802.3ct SIGNAL_DETECT modifications

Eric Maniloff (Ciena)

July 24, 2020

Figure 153–7—SC-FEC synchronization state diagram

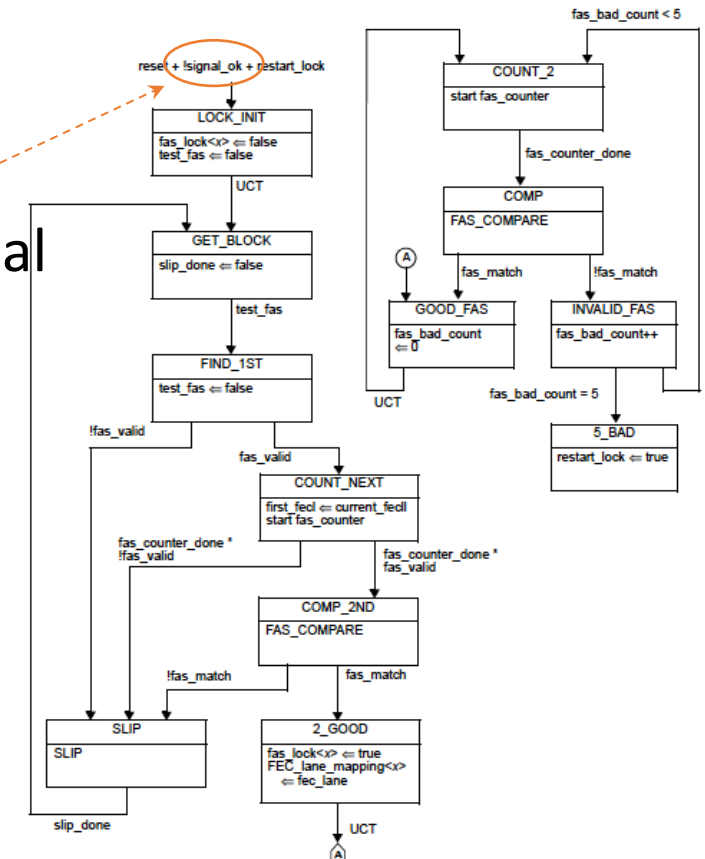
- When SIGNAL_DETECT = FAIL, traffic will be squelched, as shown in Fig 153.7
- For unamplified applications, the SIGNAL_DETECT threshold is set to the launch power of OFF transmitter power level

- As SIGNAL_DETECT is not reliable using average power detection:
 - The proposed solution is to have only one row in Table 154-5, indicating the value “OK” for SIGNAL_DETECT, removing the other 2 rows for value “FAIL” and “Unspecified”.
 - Add appropriate wording in the text around Table 154-5 to clarify the reason why this is done.
- Lane Lock at SC FEC will be used to verify a valid data signal

Figure 153–9—100GBASE-ZR PMA functional block diagram

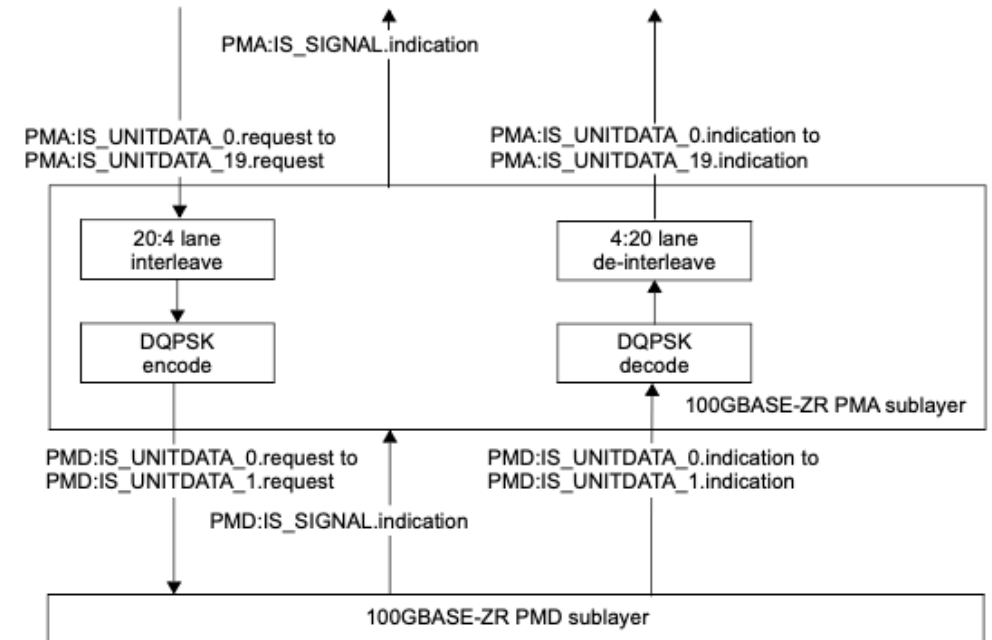
- An inter sublayer indication of SIGNAL_DETECT status is defined between the PMD and SC FEC sublayers
- This connection will be maintained, with the value fixed at OK
- This maintains common IS connections as other clauses
